OREGON CITY

- FILE NO.:** HR 13-02
- HEARING DATE:** Tuesday, May 28, 2013
7:00 p.m. - City Hall
625 Center Street
Oregon City, Oregon 97045
- APPLICANT:** Bill Heintz, Mountain Ridge Homes LLC
P.O. Box 102
Boring, OR 97009

- LOCATION:** 3 1E 041AA Tax Lot 1501
4th Avenue, Oregon City
- REQUEST:** Approval of a new single family residence in the Canemah National Register District. The applicant is additionally requesting a Preservation Incentive to allow for adjustments to the front setback.

4. DRAWINGS

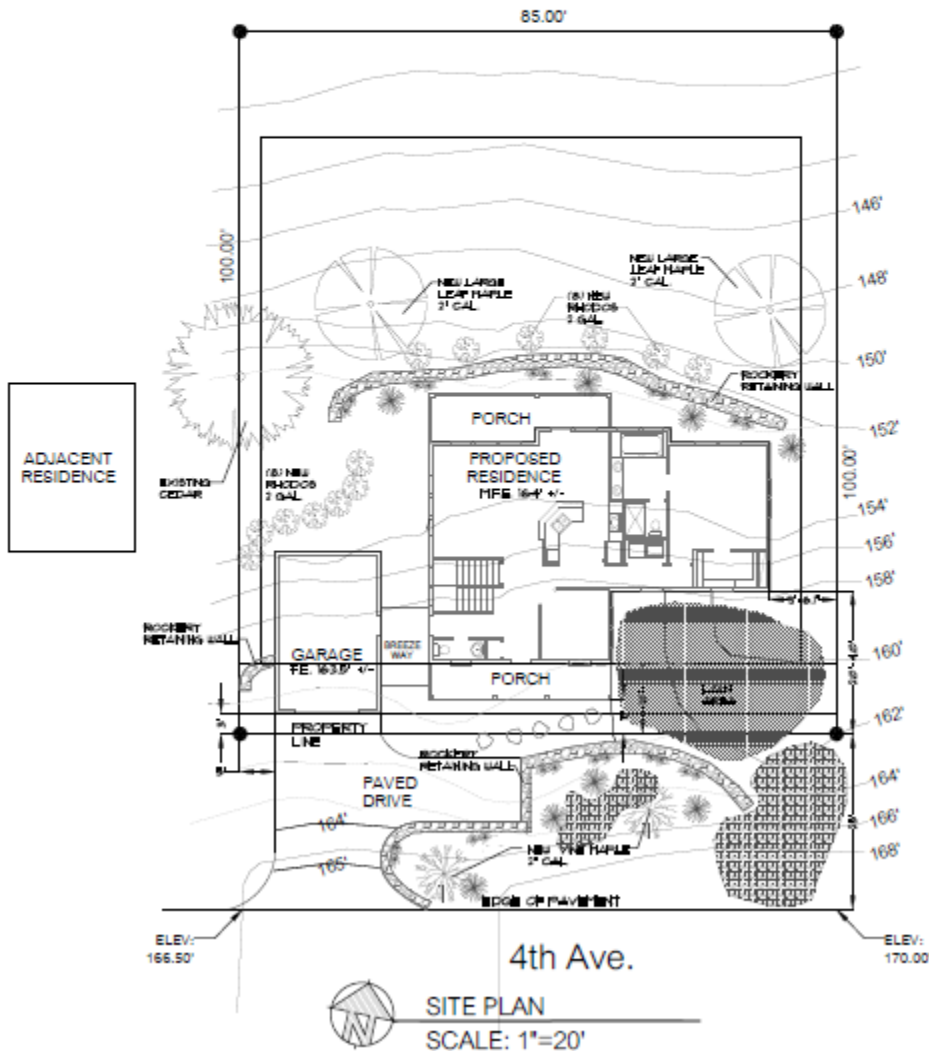
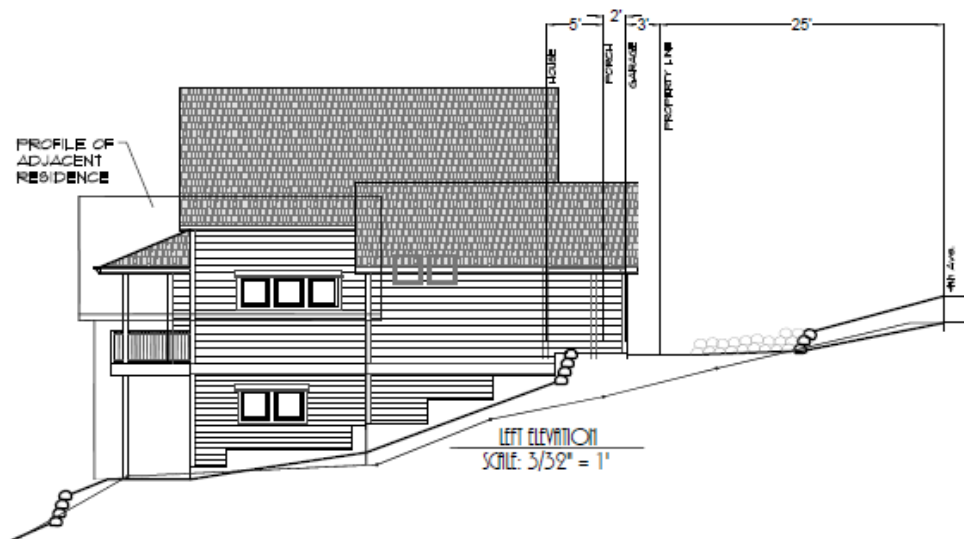
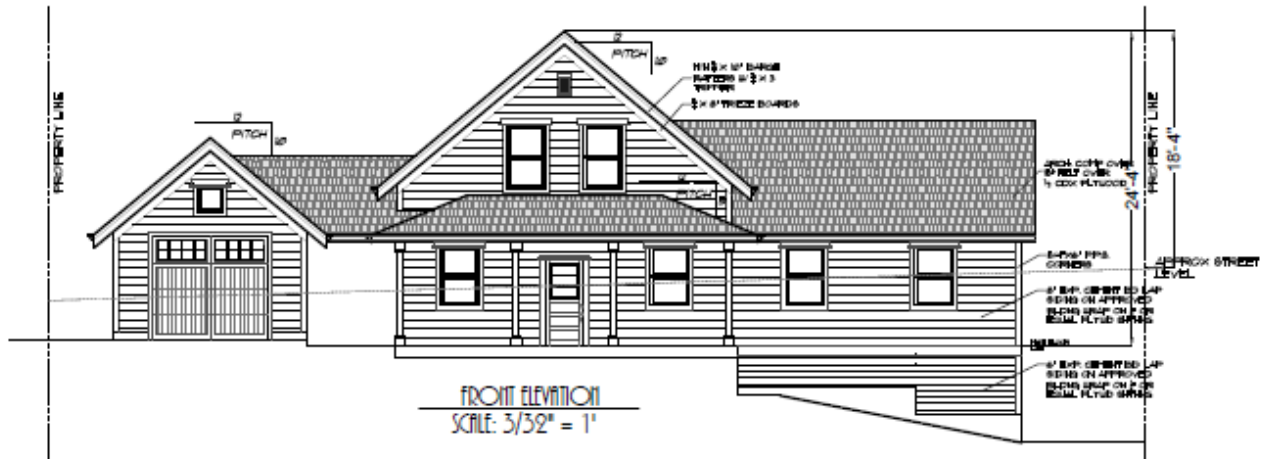
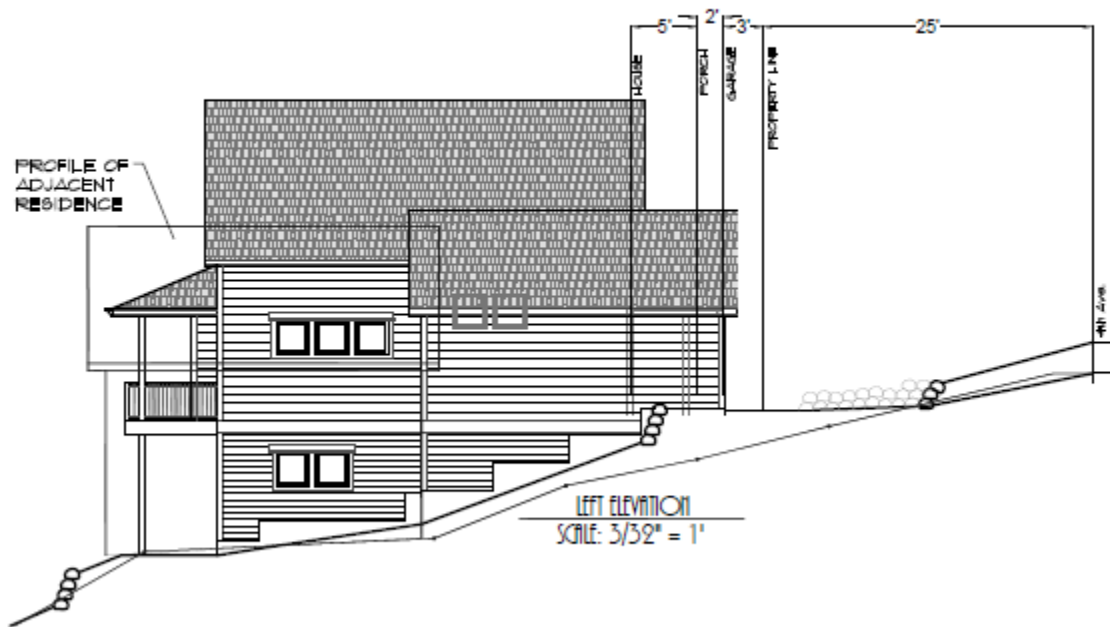
Paul Edgar, Canemah Land Use chair, submitted concern over the location of the garage, specifically if the placement up to the street will further block the Draper house from public view. However, staff is uncertain if moving the garage 5 feet back will increase the public's view of the Draper house to a discernible measure that will justify the increase in the pitch and location of the driveway. Staff is supportive of the move to increase the setback of the garage if it can be shown that it will not adversely affect the pitch of the elongated driveway and it will not affect the dripline of the large cedar tree to the rear of the garage at the property line of the Draper house.

The applicant has also indicated that the revised survey (which will be submitted to the Historic Review Board at the night of the May 28th Hearing) may affect the location of the garage and house thereby reducing the width of the breezeway between the house and the garage. Therefore, prior to building permit submittal, the applicant shall submit revised drawings that show the garage has a minimum separation of 5 feet from the main house to allow for adequate separation between the two building masses.

Finding: Paul Edgar, Neighborhood Chair of the Canemah Neighborhood Association, submitted comments regarding the use longer and skinner windows (2.6x60) on the front elevations and utilizing a steeper roof pitch of 12:12. Staff has included the relevant design guidelines above that speak to these comments.

The design guidelines call for a lower pitch on Vernacular additions. The applicant has proposed 10:12 for pitch for both the main and cross gable addition. Prior to submitting permits, the applicant shall redesign the main roof pitch to be 12:12. This will not only differentiate the main and secondary volumes, it will help in breaking up the horizontal massing the proposed new construction

In order to meet the spacing guidelines identified above, staff recommends that the applicant supplement the proposed landscaping plan with additional mitigation/screening trees. Specifically, prior to obtaining a Certificate of Occupancy, the applicant shall submit an amended landscape plan that includes the following:

- 5 additional bushes with a mature height of 4-6 feet and two additional trees with a mature height of 30 feet or more planted within 30 feet of the west property line to better block the garage from the Draper House
- 5 additional bushes with a mature height of a minimum 4-6 feet along the east elevation to break up the massing of the day light basement

- b. wood or a minimum 8-inch reveal smooth composite siding
 - c. simple vernacular styled lighting.
6. Based on direction from the Historic Review Board, the applicant may increase the front yard setback to the detached garage if it can be shown that the increase will not affect the dripline of the large cedar tree at the property line.

7. The applicant has indicated that the revised survey may affect the location of the garage and house thereby reducing the width of the breezeway between the house and the garage. Therefore, prior to building permit submittal, the applicant shall submit revised drawings that show the garage has a minimum separation of 5 feet from the main house.

8. Prior to submitting permits, the applicant shall redesign the main roof pitch to be 12:12.
9. Prior to obtaining a Certificate of Occupancy, the applicant shall submit an amended landscape plan that includes the following

- a. 5 additional bushes with a mature height of 4-6 feet and two additional trees with a mature height of 30 feet or more planted within 20 feet of the west property to better block the garage from the Draper House

- b. 5 additional bushes with a mature height of a minimum 4-6 feet along the east elevation to break up the massing of the day light basement
